2006-2007 Dyna Models Replacement Transmission Cases

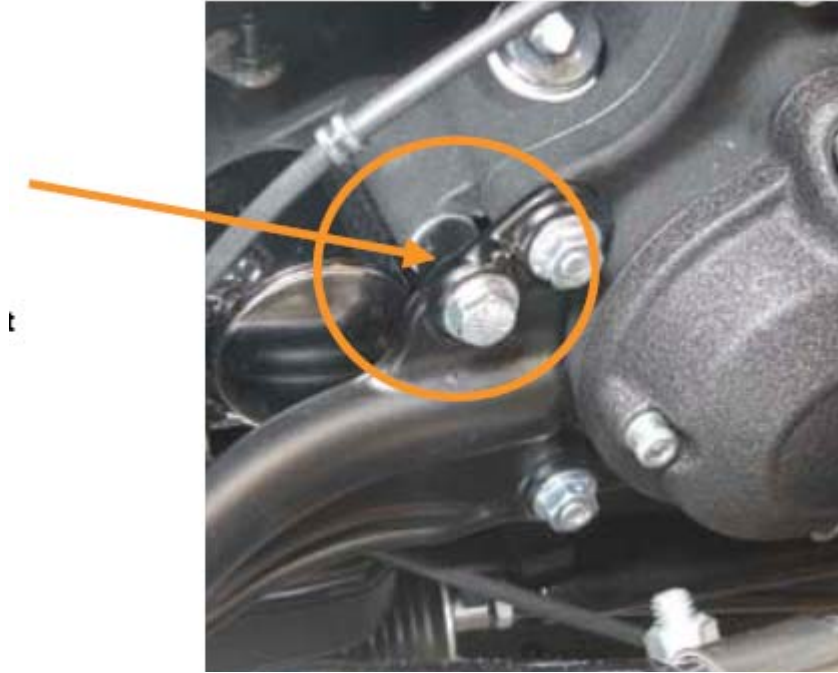
The Transmission case for 2008 Dyna Models has changed at the exhaust mounting location. The raised boss that was part of the case casting has been eliminated. The exhaust bracket now has a built in spacer and the transmission case is machined to accept it. A longer bolt is now used in this location. This is now the only case available for use on all 2006-2008 Dyna Models.

This change applies to complete transmissions as well.

If you order transmission case for 2006-2007 Dyna Models, part #'s 34746-06B (silver) or 34747-06B (black), it will come with a spacer and a bolt that will need to be used in this location when using a 2006-2007 exhaust bracket. For 2008 Models the spacer is part of the bracket.
